**BASALT WASTE ISOLATION PROJECT
ENVIRONMENTAL REVIEW**

ADDENDUM

BER-004

**Gable Mountain (NSTF) Water Line,
Trailer Move and Modifications**

Figure 1. Route of Gable Mountain Water line and New Areas (A-E) Examined In This Addendum (source USGS 1:24 000 scale Gable Butte, 1986 map).

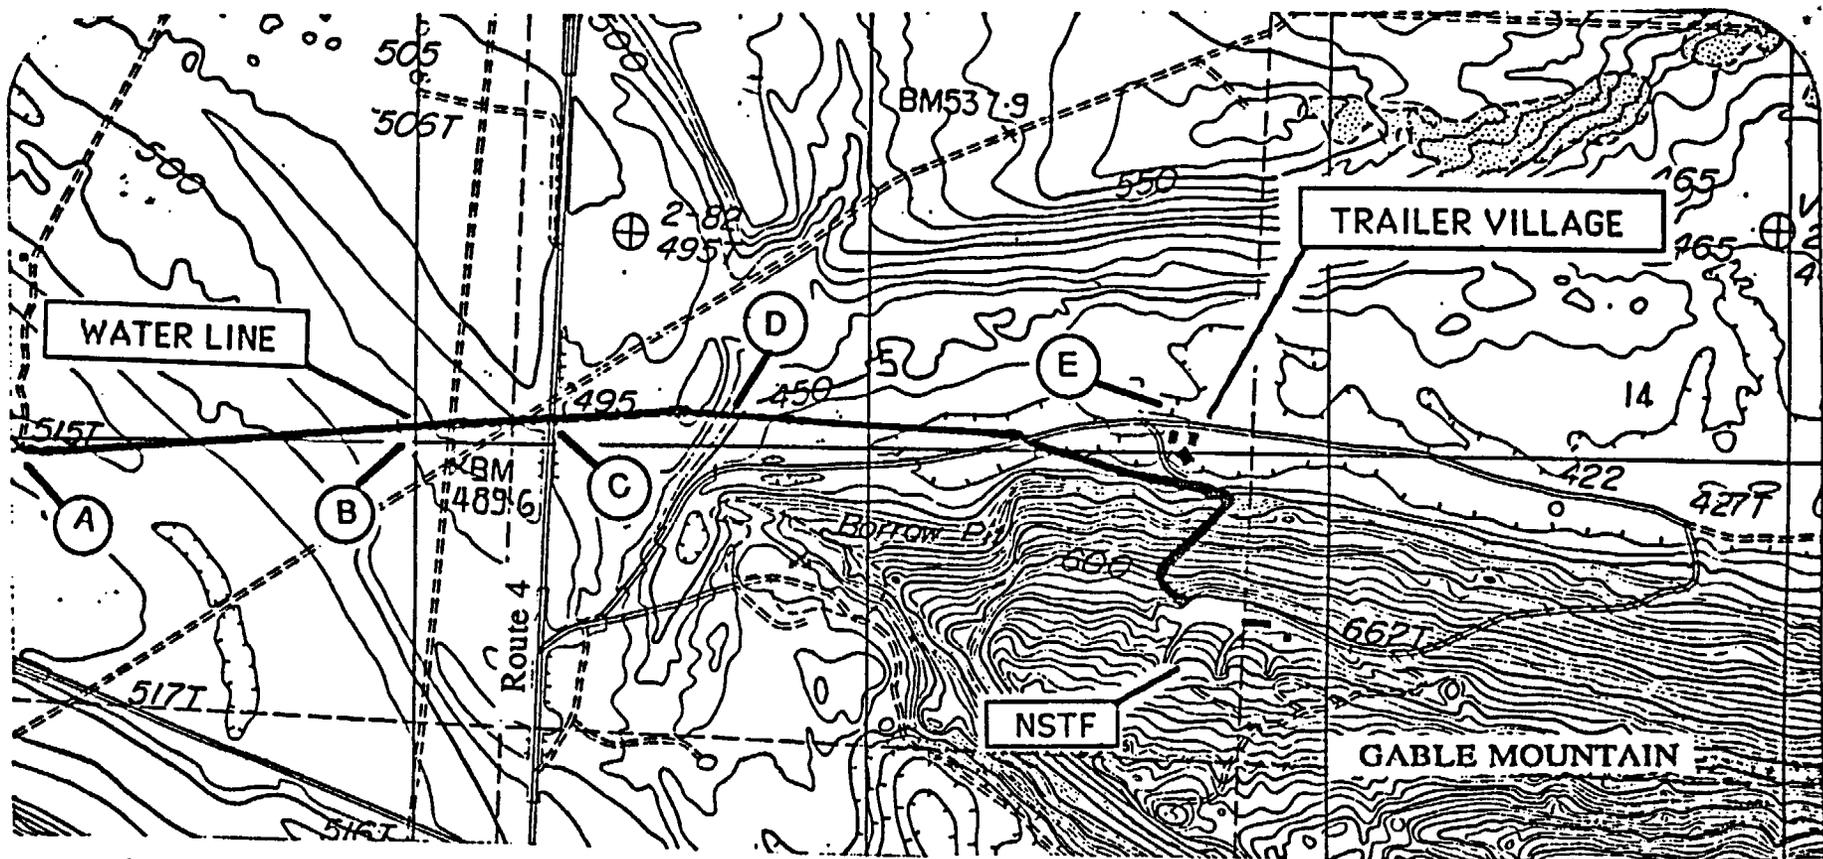
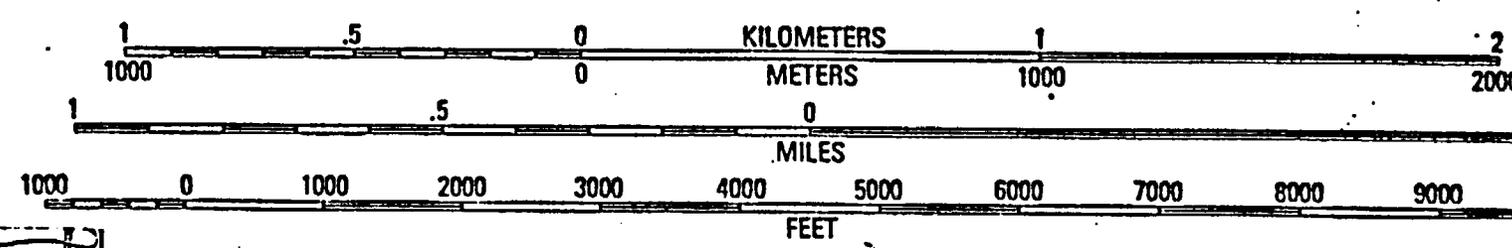
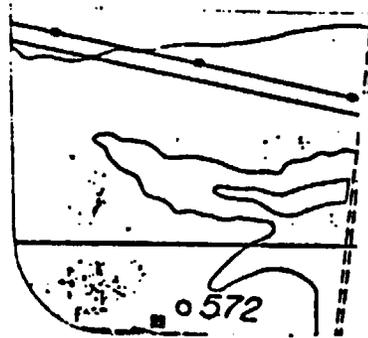
BER Ecologists and Archaeologists examined these specified areas and found no environmental resources that might be unacceptably impacted as long as the work is confined to the newly established boundaries for vehicular traffic. These areas were generally occupied by undisturbed sagebrush/cheatgrass habitat and would be used for vehicle parking and turn-around. The additional areas approved for construction activity are as follows (see Figure 1, a portion of a USGS map):

1. A truck turn-around area at the west end of the new water line approximately 372 m² (4000 ft²) in area (point "A" on Figure 1).

2. A truck turn-around area at the water blow-out pipe approximately .32 km (0.2 miles) west of Route 4, including an area of approximately 372 m² (4000 ft²) (point "B" on Figure 1).

3. Equipment parking area west and adjacent to Route 4 and the water line, utilizing part of the Route 4 right-of-way including an area of approximately .20 hec (.5 ac) (point "C" on Figure 1).

4. A truck turn-around area approximately 457 m (1500 ft) east of Route 4 at the top of the basalt outcrop, including an area of approximately 372 m² (4000 ft²) (point "D" on Figure 1).

7. We agreed that the best location for the disposal of the pipeline test water is the existing, abandoned gravel pit immediately north of the Trailer Village located at the foot of Gable Mountain (point "E" on Figure 1).

The water line project should proceed as planned utilizing/disturbing only those surface locations examined and approved in the original BER and this ADDENDUM.
